Australian Wildlife Services

23 June 2016

Review of the Rye Park Wind Farm Trust Power's 'Response to Submissions' (biodiversity)

Figure 1 Natural England's (2014) interim guidelines for buffer zones to avoid impacts to bats
Source: Natural England (2014)

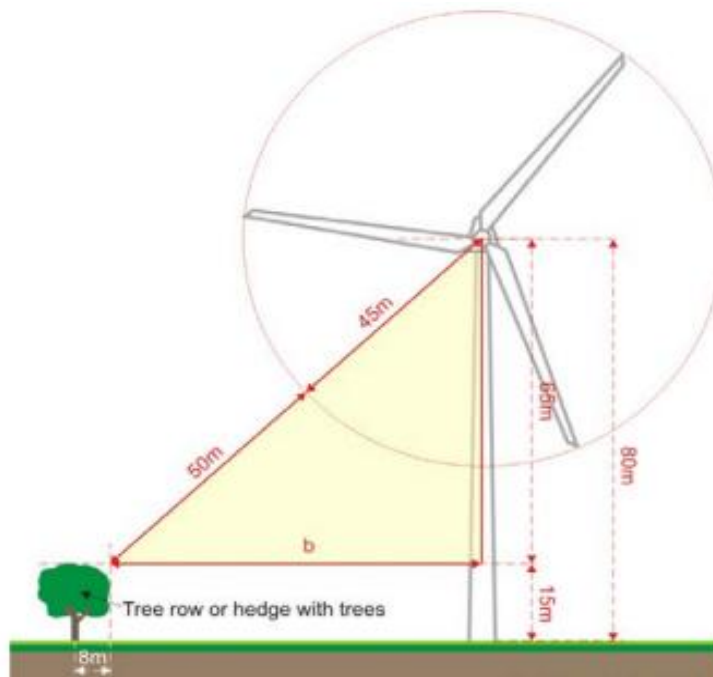
In the updated Biodiversity Addendum (ngh 2016), the 70 m buffer is suddenly referred to as an ‘accepted’ formula by Natural England (2012). However, this reference is missing from reference lists in both the Main Report and Appendix C Biodiversity Addendum and cannot be found by internet searches or in other documentation. Therefore, it is difficult to determine the source of this claim. Apparently the OEH agreed to the 70 m buffer distance despite documentation requiring a minimum of 100 m be applied.

We were able to locate a formula published by Natural England (2014), presumably an update of the 2012 version, produced as interim guidelines for setting buffer areas to reduce potential adverse impact to English bats (Natural England 2014). The formula is:

$$b = \sqrt{(50 + bl)^2 - (hh - fh)^2}$$

Where bl = blade length, hh = hub height, fh= feature height (in metres) and 50 (m) is the recommended distance between the moving blade tips and the nearest feature.

See Figure 1.

If this formula applied to the current Rye Park wind farm layout and turbine design specs¹ described by Trust Power (2016), the buffer should be approx **90 m** measured between the base of the turbine footings to the nearest edge of the vegetation canopy / habitat. Thus a 70 m buffer applied to this wind farm to ‘avoid’ impacts is not great enough and probably underestimates potential impacts.

Despite the assumed discrepancy in buffer areas applied using the Natural England formula and lack of documentation describing how the buffer zone was calculated; the guidelines are specific to English species of bats. Impacts to Australian bats and Australian birds are not considered by this formula and are unlikely to be appropriately applied across all species. A worst-case scenario in any event should be applied when determining the impact and 70 m is unlikely to be appropriate for all species.

AWS is unaware of similar evidence based or even interim guidelines for Australian conditions. We recommend the OEH/Commonwealth Department of Environment to develop independent Australian specific wind farm infrastructure setback guidelines for threatened and important habitats. Studies should be funded by industry proponents but conducted by independent agencies and subject to peer review.
